New softening equipment for all 45cm and 60cm dishwasher models with a TURBO dryer (fan)

As of serial number 347 ... (November 2003) a new rinsing chamber with a new support at the top is being introduced for some of the dishwashers produced.

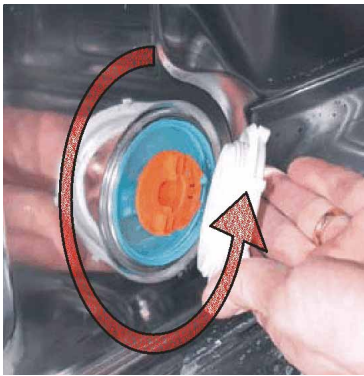
The modification is being carried out in order to improve the system.

Using a hose which connects the softening equipment supports with the bottom of the dishwasher makes it easier for the condensation water at the top of the condensation cycle to drain off, hence improving the drying process.

The water that collects in the left water collector on the bottom of the dishwasher can thus evaporate.

The new softening equipment can only be replaced with the specific kit and if the steps described in the following "instructions for technicians" are followed.

The new spare-part no. 435 114 (large softening equipment for electronic appliances) is therefore replaced with this kit.

a

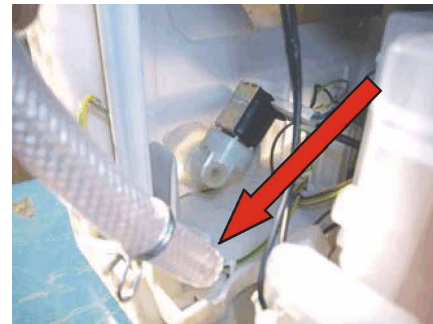
- a. Remove the vapor discharge screen from the inside of the container.
- b. Remove the base and the lower front cover.
- c. Remove the left side panel.
- d. Remove the hose that connects the softening equipment to the water intake valve.
- e. Carefully lift up the drying duct and loosen the softening equipment. Make sure that
 - o the sponge gasket located between the softening equipment and the drying duct is not damaged;
 - o the cable leading to the fan motor is not damaged.

Carefully pull the softening equipment upwards in order to avoid damaging the O rings between the softening equipment and the pan.
